# 2 Angel Square

Planning Addendum - MMA

August - 2024

Planning Review

4. 2 Angel Square August 2024  
GA Plan - L12

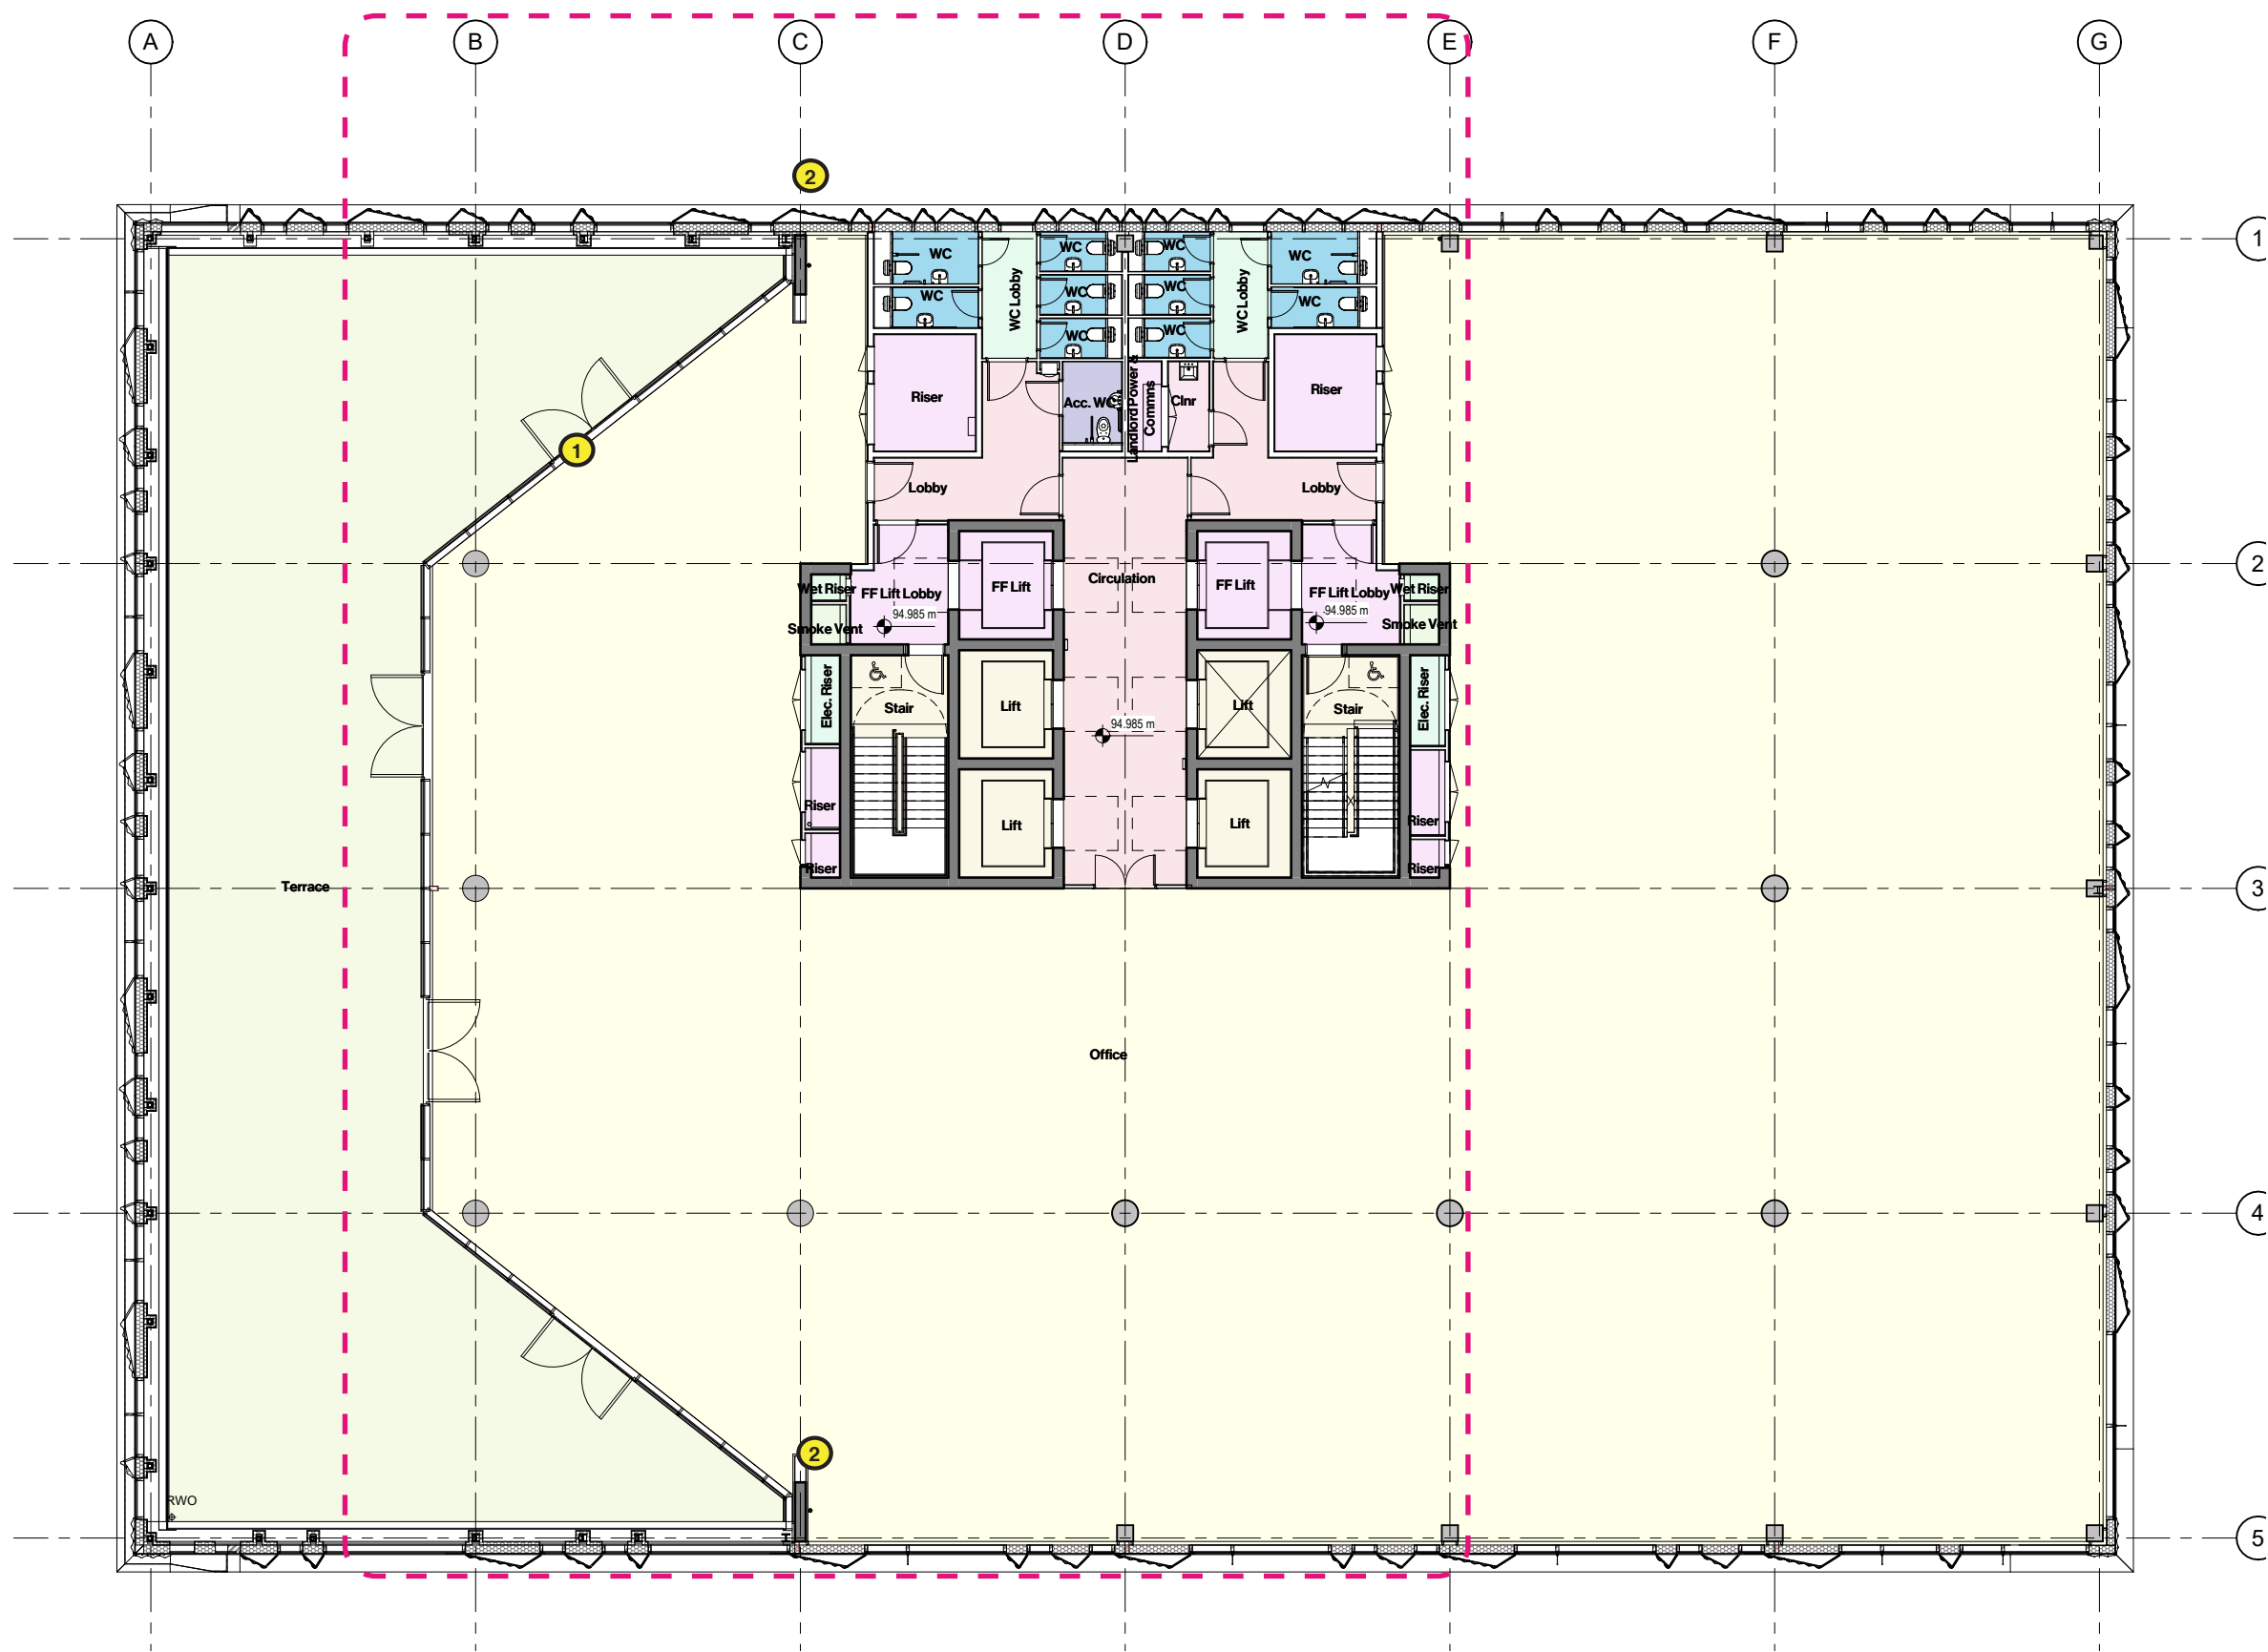
- 1. External wall re-arranged between Level 12 & roof terrace. Extent of external wall reduced **NIA increased to 1260sqm** (Planning: 1188sqm)
- 2. Minor areas of lowered ceiling height at boundary with facade.

4. Revised cill profile (June 2024)

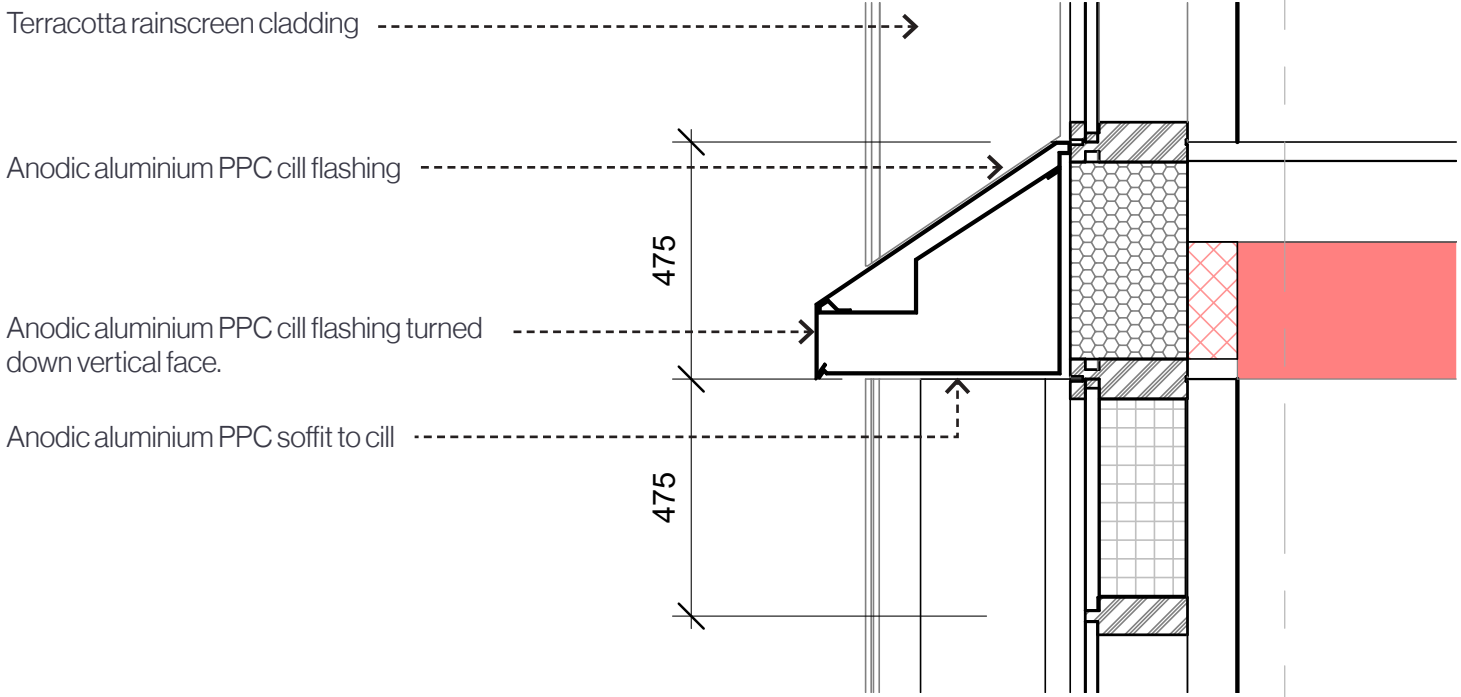
Over emphasis of the projecting cill and associated colour tone.  
The use of GRC and how it weathers.

Proposed amendments to Cill profile at all levels:

- Material change from GRC and aluminium to all aluminium. Simplifies detailing, reduces facade weight and minimises additional fixings and associated embodied carbon.
- Flat PPC aluminium soffit introduced in place of sloping GRC soffit. Horizontal soffit reduces visual impact of underside of cill.
- Top cill made steeper to improve weathering and stop roosting.

# Typical Facade Bay - Cill & Panel comparison

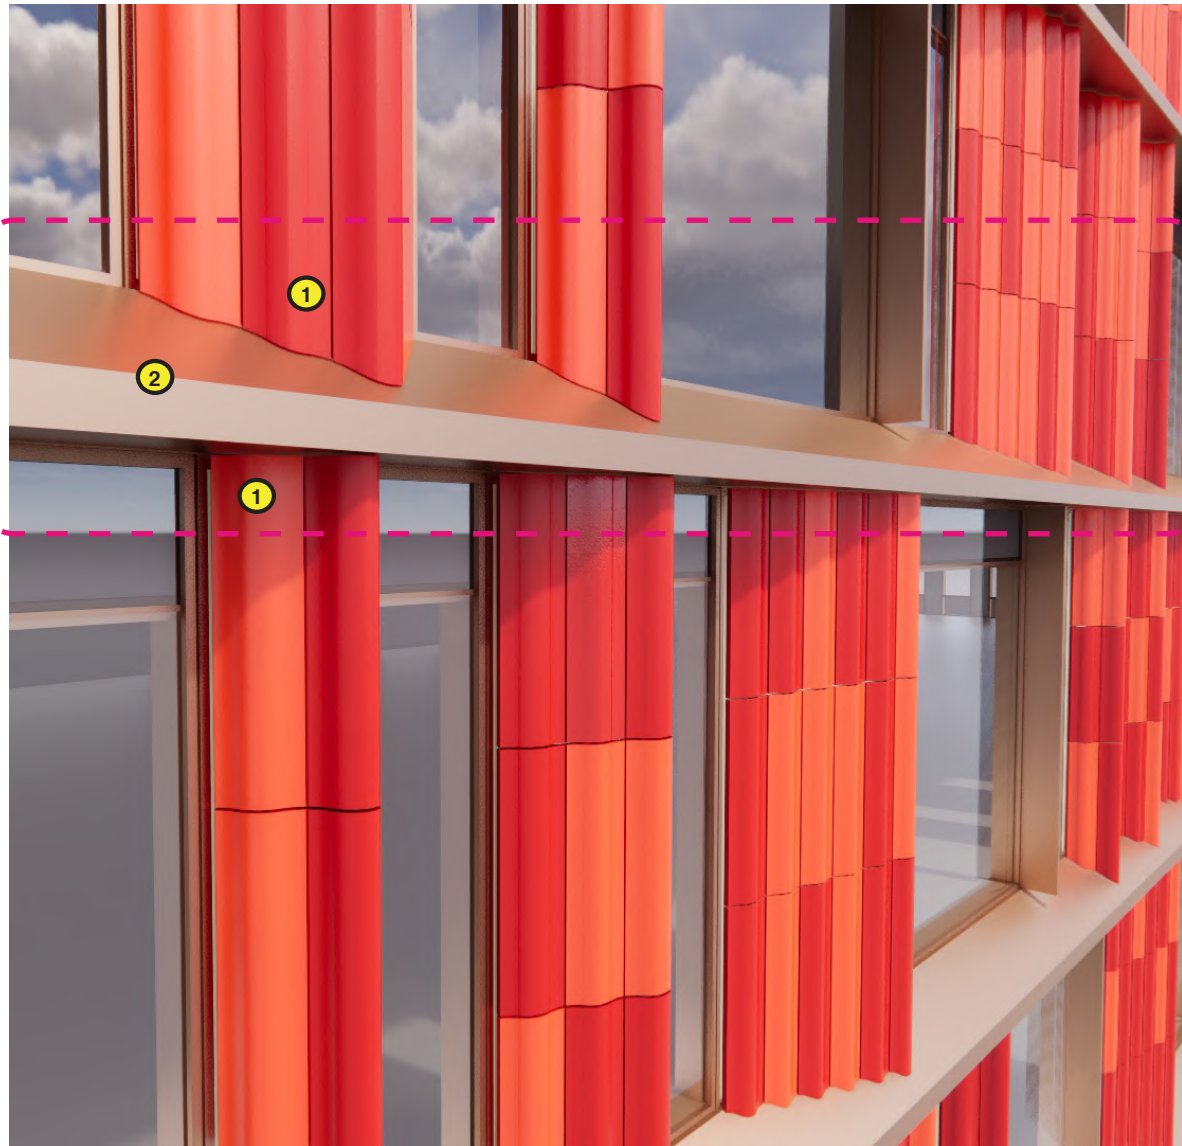
- Proposed**
- 1. Terracotta panel profile changed (All Levels).  
- Flat cut edge of top row of tiles to underside of cill,  
- Steeper slope cut to bottom row of tiles
  - 2. Cill profile changed (All Levels).  
- Flat soffit and steeper top sill  
- Material change from GRC and Aluminium to all aluminium.

# 6. 2 Angel Square GA Elevation Comparison- NW

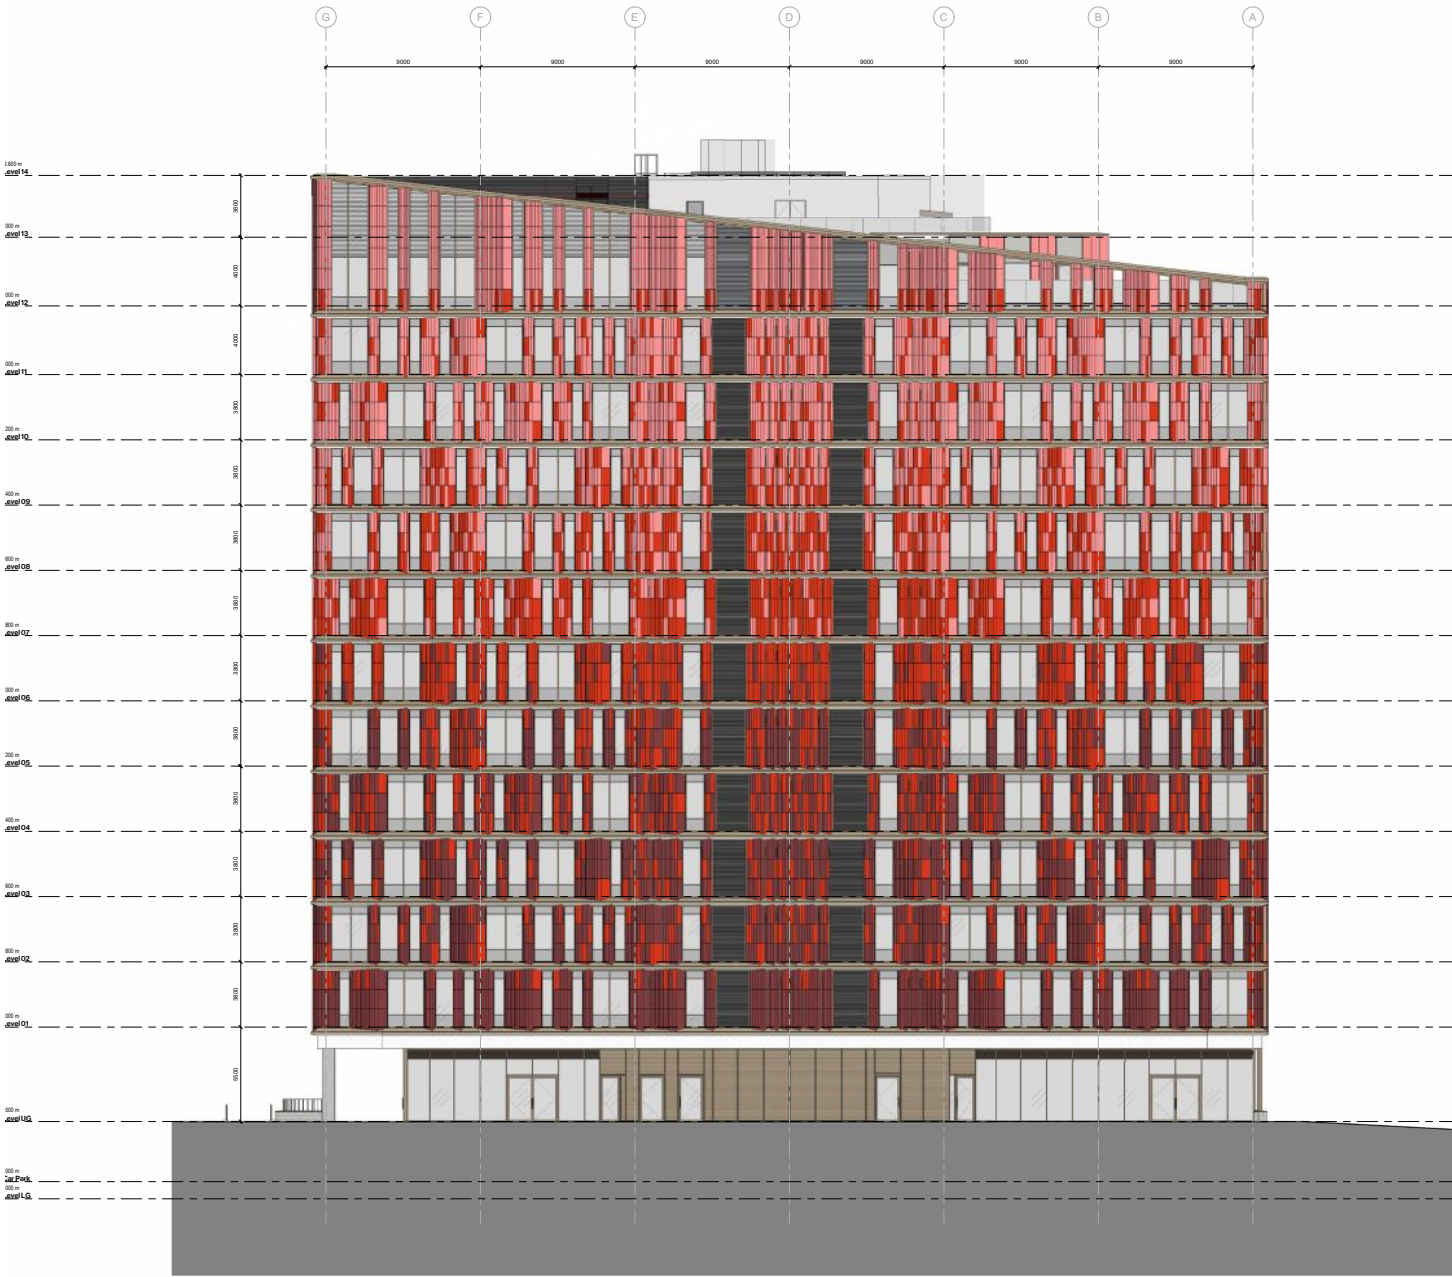
1. Level 12 envelope extended to suit revised layout. Bronze anodic aluminium cladding to level 12 terrace elevation.
2. Louvre screen extended to conceal revised roof top plant area.
3. Cill material and profile adjusted to all floor levels.
4. Structural glass balustrading

# 7. 2 Angel Square August 2024 GA Elevation Comparison - NE

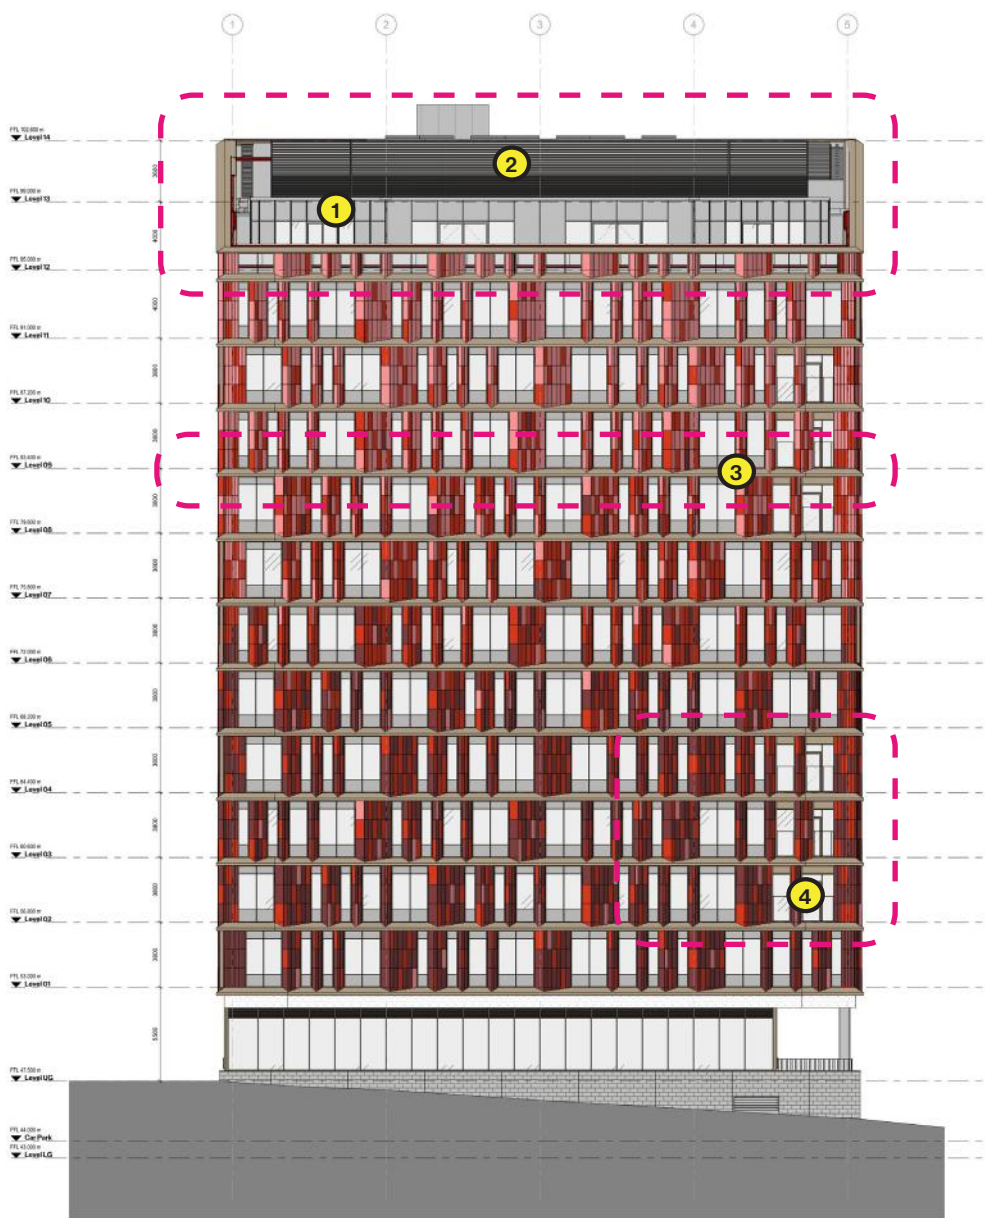
1. Level 12 envelope extended to suit revised layout. Silver anodic aluminium cladding to level 12 terrace elevation.
2. Louvre screen extended to conceal revised roof top plant area.
3. Cill material and profile adjusted to all floor levels.
4. Structural glass balustrading
